**CITY AND COUNTY OF DENVER  
DEPARTMENT OF PUBLIC WORKS**

<b>CONTRACT NO. 201951264 PROJECT NAME: 56<sup>TH</sup> AVE AND PENA BLVD INTERCHANGE ADDENDUM NO. 3 TO CONTRACT DOCUMENTS</b>
--

56TH & TELLURIDE EXPRESS

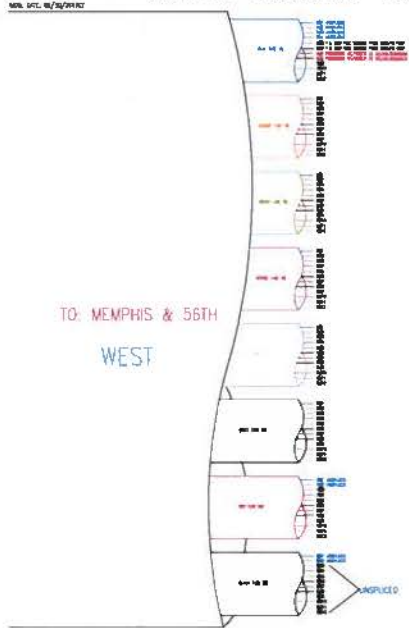
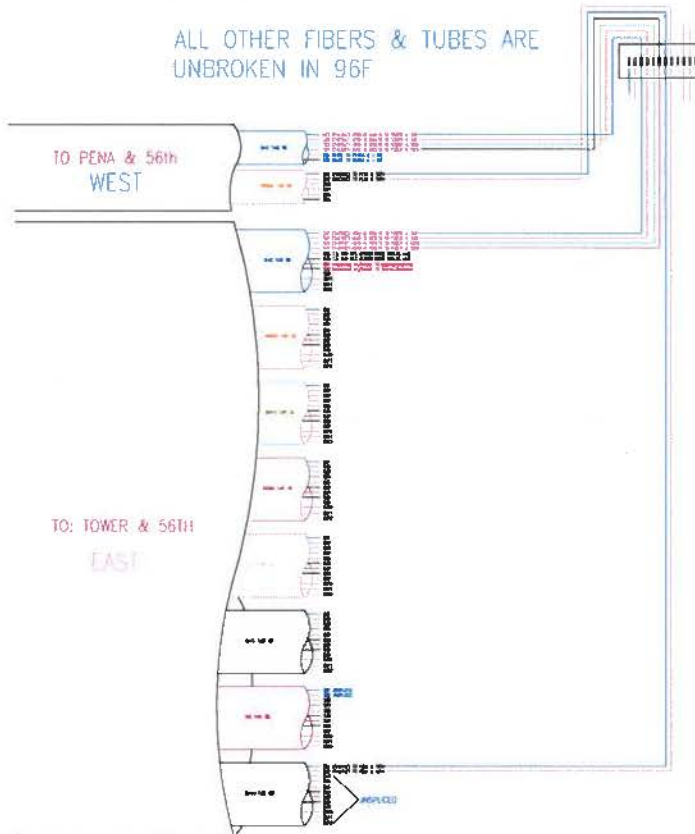
Q12: Can the City provide a splicing diagram for the fiber optic cable?

ALL OTHER FIBERS & TUBES ARE  
UNBROKEN IN 96F

SOME OF THESE MAY BE DAMAGED  
DUE TO HIT BY CONTRACTORS  
WORKING ON THE BRIDGE EXPANTION  
- THE 6X6 TO THE EAST WAS CUT  
AND ABANDONDED

**A12: Splice enclosures are added as part of this addendum.**
